To: T13 Technical Committee  
From: Rob Elliott, HP (elliott@hp.com)  
Date: 6 November 2009  
Subject: e09150r0 EDD-4 Hybrid MBR partition records annex

**GPT support for hybrid MBR partition records**

**Figure B.1 — GPT disk layout with hybrid MBR partition records example**

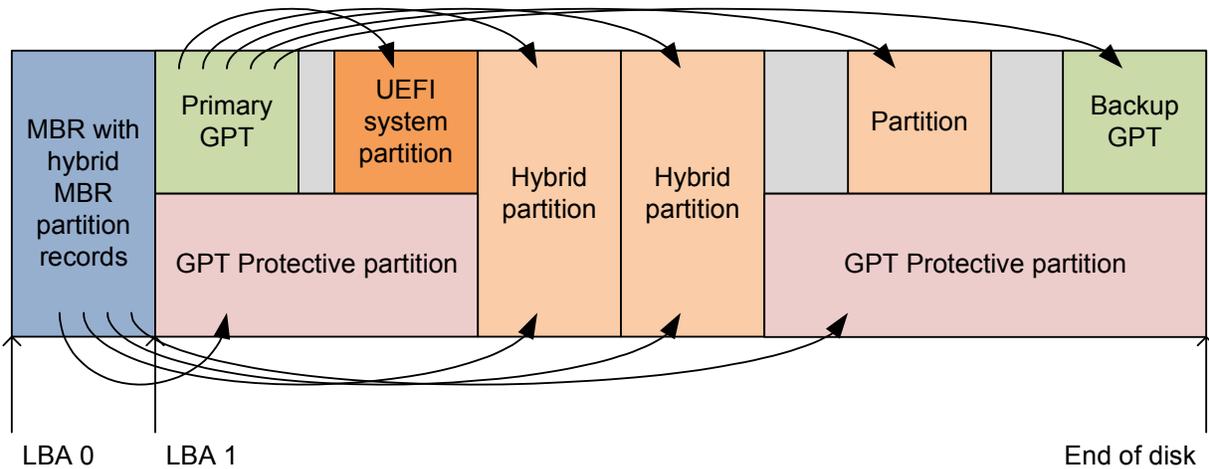
Figure B.1 shows an example of hybrid MBR partition records.

Figure B.2 — GPT disk layout with hybrid MBR partition records truncation example

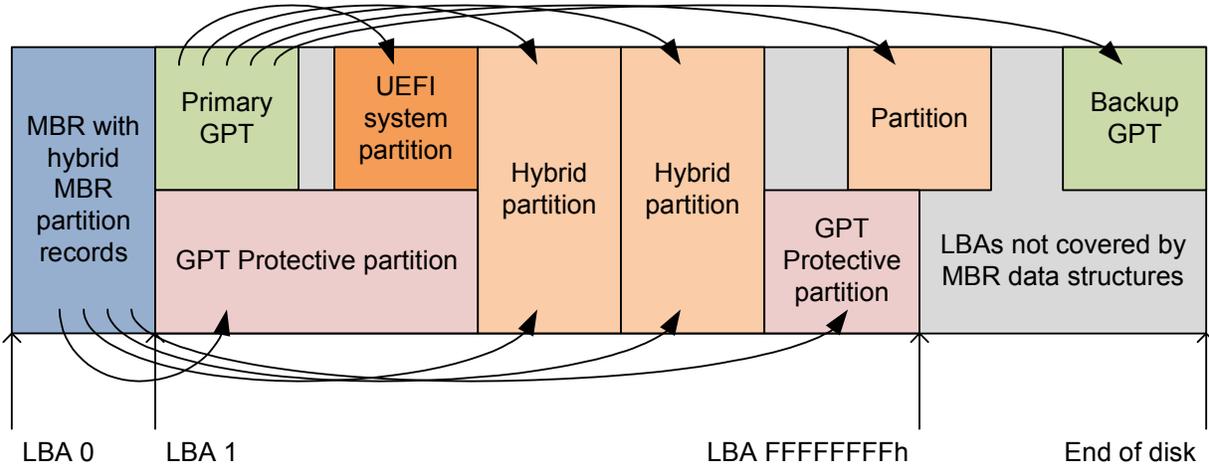
Figure B.1 shows an example of hybrid MBR partition records on a disk with an ending LBA greater than FFFFFFFFh. The MBR partition records are not able to describe the LBAs above FFFFFFFFh.
